# Access Compliance Report

## Public Rights-of-Way

| Intersection ID: 10252                                                                                                                                                                                                                                                                                                                         |  | Main Street: MATHIS_DR  |  | Cross Street: ROGERS_ST                 |                       | Location: W            |            |                             |         |  |  |  |  |
| ADA ID: 4B22A84ADEF4                                                                                                                                                                                                                                                                                                                           |  | Ramp Type: Directional1 |  | Initial Pass/Fail: Pass                 |                       | Overall Compliance: No |            | Severity Score: 2.5         |         |  |  |  |  |

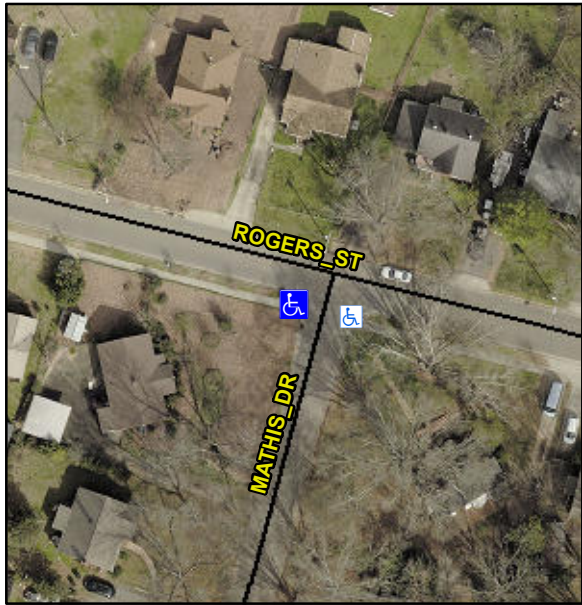
|                                                                                                                                                                                                                                                                                                                                                |  |                         |  | No                                      | Landing X Slope (%)   | 2.8                    | No         | DWS Full Width?             | No      |  |  |  |  |
|                                                                                                                                                                                                                                                                                                                                                |  |                         |  | N/A                                     | Shared Landing?       | No                     | No         | DWS Offset RT (in)          | 5.0     |  |  |  |  |
|                                                                                                                                                                                                                                                                                                                                                |  |                         |  | Yes                                     | Gutter Lip Ht (in)    | 0.0                    | No         | Gutter X Slope (%)          | 2.7     |  |  |  |  |

| <div></div> <div>Possible Solutions:<br/><br/><b>Remove &amp; Replace Entire Ramp.</b><br/><b>Remove &amp; Replace Gutter.</b></div> <div>Surveyor Notes:<br/><br/><b>N/A</b></div> <div>PROW/ADA:<br/><br/><b>Not Found, R304.5.3, R305.1.4, R305.2</b></div> |  |                         |  | Compliance                              | Description           | Data                   | Compliance | Description                 | Data    |  |  |  |  |
